Administrative Approval Action

AA #3972 / S-58-18, Macon Pond Subdivision
Transaction# 573665

REQUEST: Subdivision of a 27.22 acre tract zoned OX-12 CU (Z-8-18) into a four (4) lots in two phases.

REFERENCE: Amendment to Design Adjustments for S-58-18
Transaction # 573665
Macon Pond Subdivision

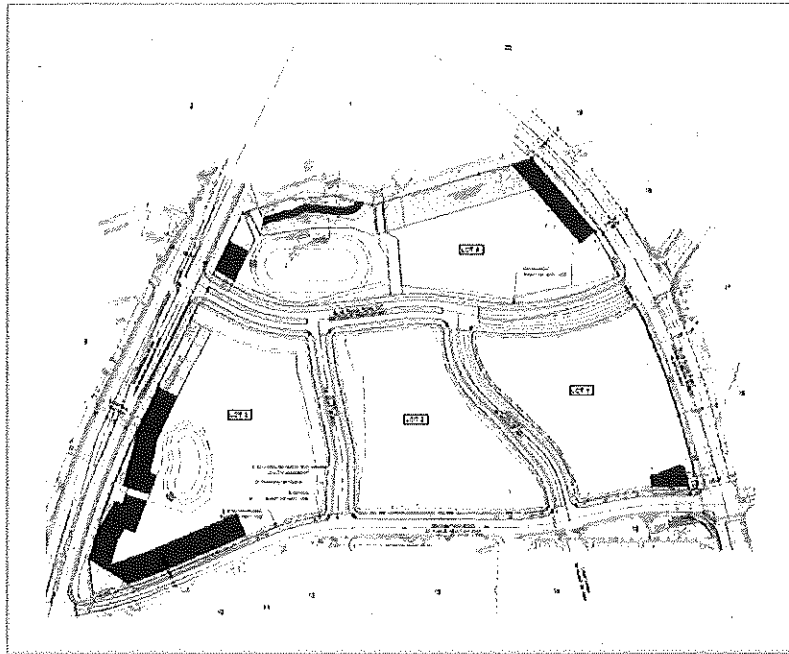
The Macon Pond site is 27.22 acres, and is zoned OX-12-CU. The site currently has frontage on Edwards Mill Road, Blue Ridge Road, and Macon Pond Road, and the subdivision of the site will result in the creation of 3 additional roads: Blue Ridge Road extension, Lake Drive, and "Street B". 4 lots will be created out of the subdivision as shown in the plan below.

Because of the unique nature of the site and surroundings, this project requires two Design Adjustments:

- 1) 8.3 Block, Lots, Access related to cross access requirements offsite from Block 4 to development to the north, and
- 2) 8.5 Existing Streets related to Edwards Mill Road and Blue Ridge Road dimensions and placement of streetscape components.

Blue Ridge Road Corridor Study

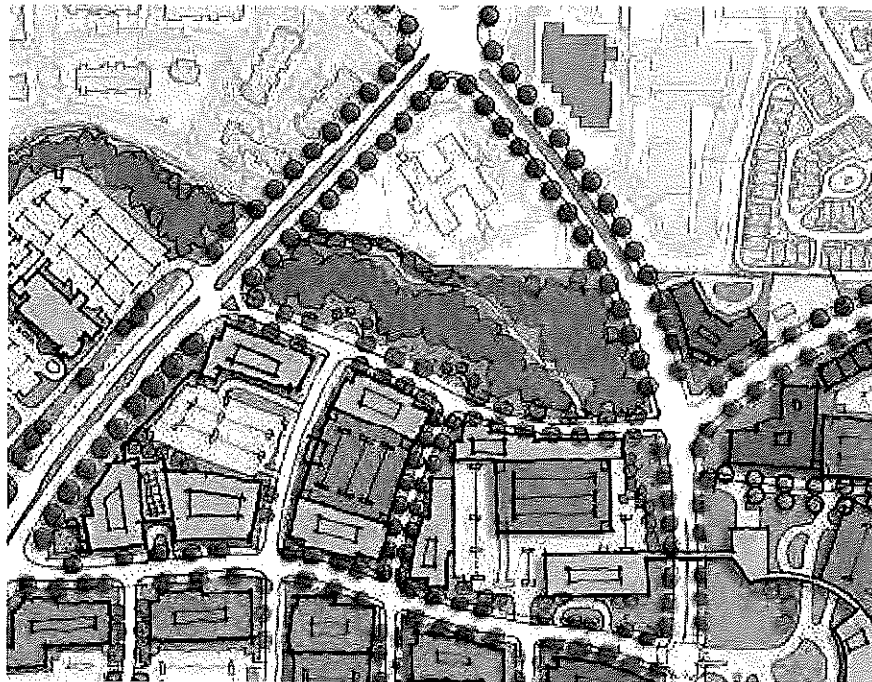
The Blue Ridge Road Corridor Plan shows Site 4 as an undisturbed natural area with no cross-access to development to the north. The proposed design adjustment is consistent with this plan.

126' Avenue 6-Lane, Divided section

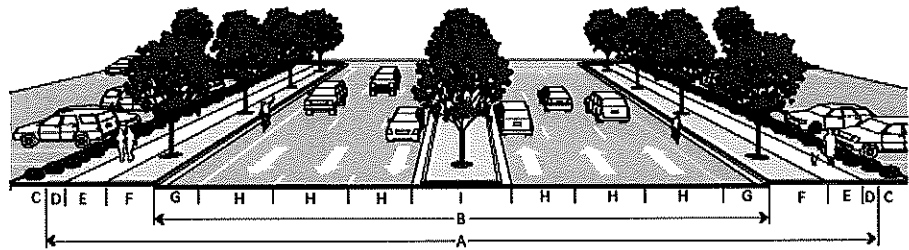
Edwards Mill Road right of way is currently 150' in width, which is 24' in excess of the Raleigh Street Manual's 126' requirement for Avenue 6-Lane Divided. During previous development of the site, Tree Conservation Areas were platted directly adjacent to the Edwards Mill frontage. Because of the abundant right of way, NCDOT rules regarding placement of street trees, and TCA constraint, we request a design adjustment to permit the existing condition to remain: planted median, 2 through traffic lanes, curb and gutter, turf strip and 5' sidewalk to remain unchanged, and the addition of street trees behind the sidewalk as well as placement of the 5' utility strip within the right of way rather than in an easement on private property. Where a new turn lane is added, the 2.5' turf strip, 5' sidewalk, street trees and utility placement will echo the pattern of the existing condition.

There is excess dimension in the Edwards Mill Road right of way that would permit the placement of a utility strip without compromising the full street section as called for in the Raleigh Street Design Manual.

Raleigh's Street Plan identified Macon Pond Road as an Avenue 2 lane Divided with the following dimensional requirements:

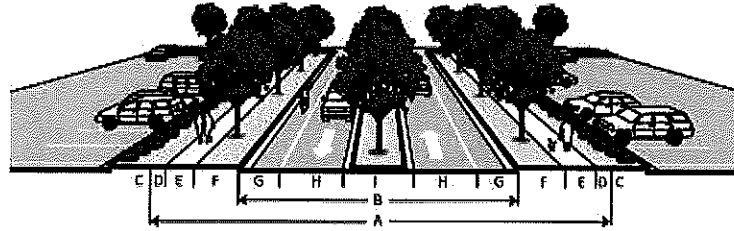
In order to provide 1/2 of the City-required right of way for Macon Pond Road, we are further encroaching into the Duke Energy easement by widening the road to the north. The curb is currently 26' from the power structure; the planned widening of Macon Pond Road places the curb will be 19' from the power structure.

As a result of Duke Energy's rejection of the standard street section and extensive conversation with their staff, the Project Team provided two options that were a compromise between COR and Duke Energy requirements. We believe based on discussion with Duke Energy that the following modifications comes closest to meeting their requirements:

- Revise the alignment for Macon Pond Road such that it shifts the road to the South.
- 5' City of Raleigh Utility Placement Easement ends at the 100' CP&L Easement.
- Shift 6' sidewalk to the back of curb, so the sidewalk is 27.0' from structure #459.
- Back of curb of the roadway improvements will be 33.0' from structure #459.
- This option will require roadway widening on the EB lane but the installation would be staying in the existing right-of-way. Power pole relocation will be required for the existing pole near the Edwards Mill Road intersection and possibly a second along Macon Pond Road in the 100' CP&L Easement. We would also be required to make storm drainage upgrades along the South Edge of the EB lane since the roadway will be changing from a ditched section to a curbed section.

As a result of this conversation, we respectfully request a Design Adjustment for the following modifications along the Macon Pond Road adjacent to the Duke Energy easement:

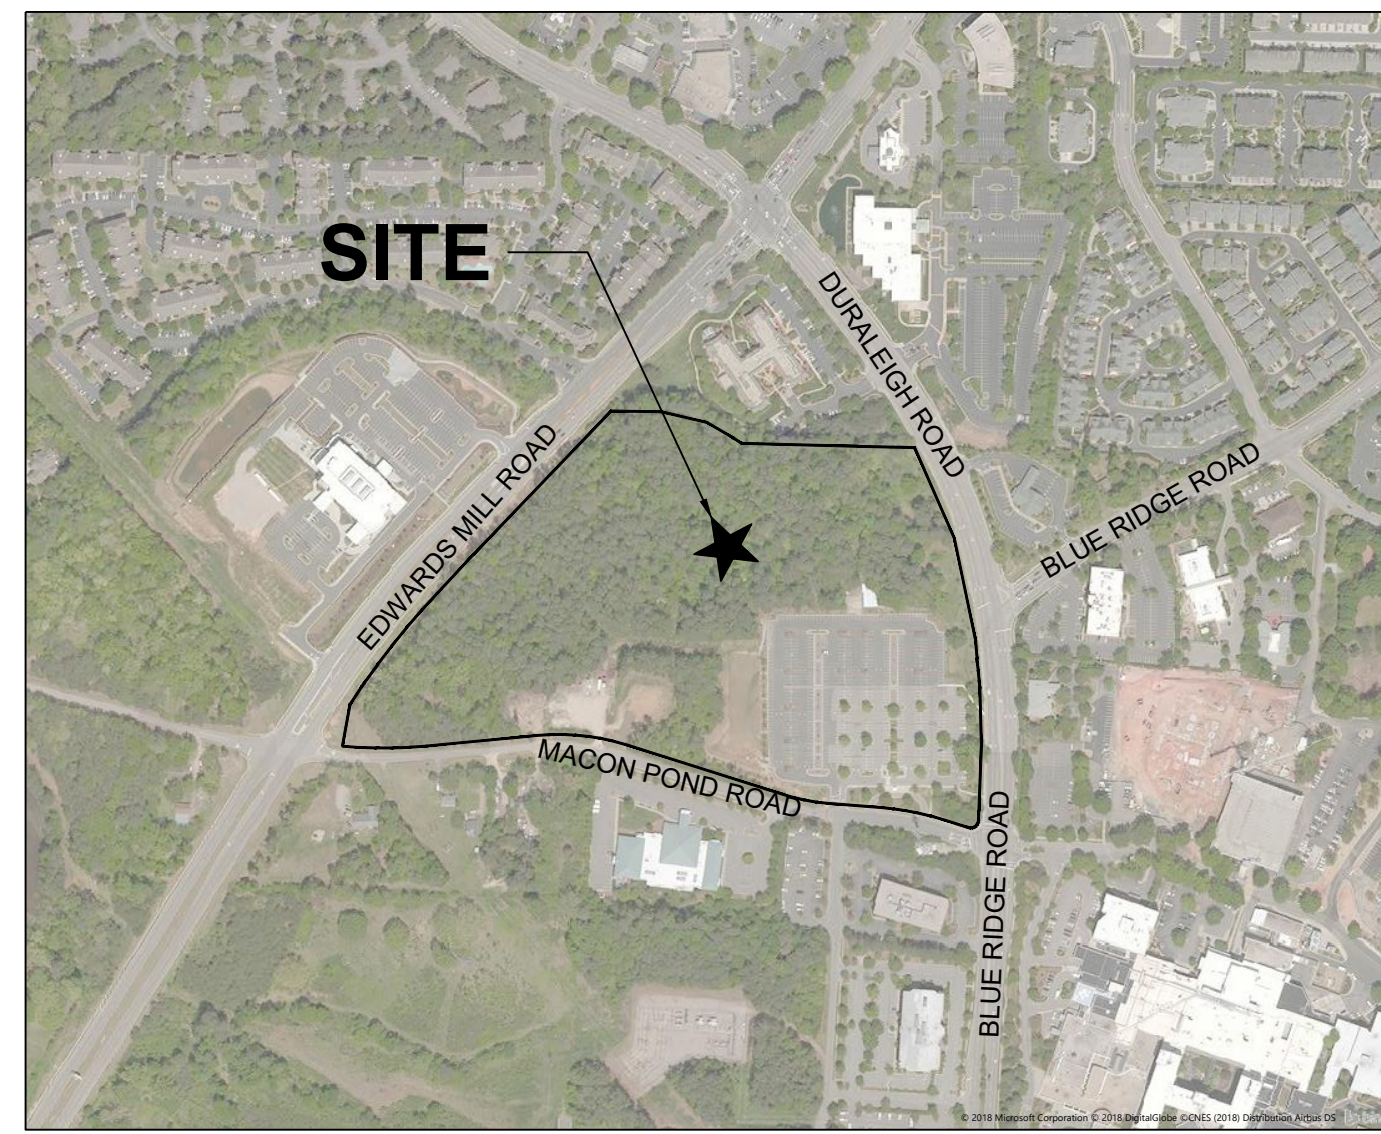
Duke Energy Transmission (“DET”) has made a review of your proposed Macon Pond Road expansion, utility easement, grading, and sidewalk improvements and is hereby denies these plans as shown on the above attached drawing for the following reasons:

- 1. The newly proposed street right-of-way and associated 5’ wide utility easement are within 25’ of the Duke Energy H-Frame structure # 459.
- 2. The utility easement actually is shown abutting against or within inches of the southwestern pole of the H-Frame structure.
- 3. There is also a proposed sidewalk within 25’ of the H-Frame structure # 459.

We appreciate and share your desire to enable your client to make good use of their property. Our goal is to reach an optimal solution that protects Duke Energy’s facilities by mitigating safety hazards to our workers, property owners and the general public. In this light we encourage you to revise and re-submit your plans with street rights-of-way, utility easements, grading and sidewalks that meet the Duke Energy requirements as provided to you in January.
